3R-364

Investigation Work Plan

Williams has submitted a Remediation/Investigation work plan for the Florance Gas Com J #16A 3RP-364. Williams's operators pipeline/gas gathering equipment on the referenced BP America well site.

Re: Florance Gas Com J16A – Revised Proposed Investigation Work Plan,
3RP-364, San Juan County, New Mexico

**FLORANCE GC J 16A
SITE MAP**

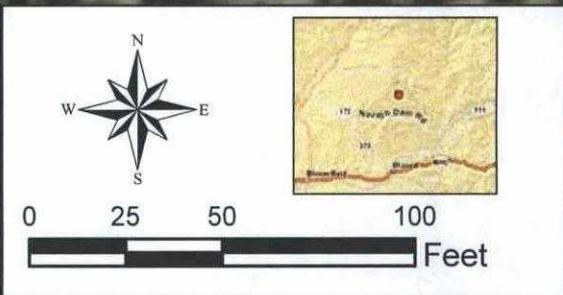
Conditions of Approval:

- Williams will provide notification to the OCD 72 hours but no more than 1 week prior to the start of the physical implementation of the work plan.
- Williams will provide notification to the OCD 72 hours but no more than 1 week prior to the collection of any conformation soil/water samples.
- Williams may be required to do additional delineation/investigation contingent upon the results of the investigation.
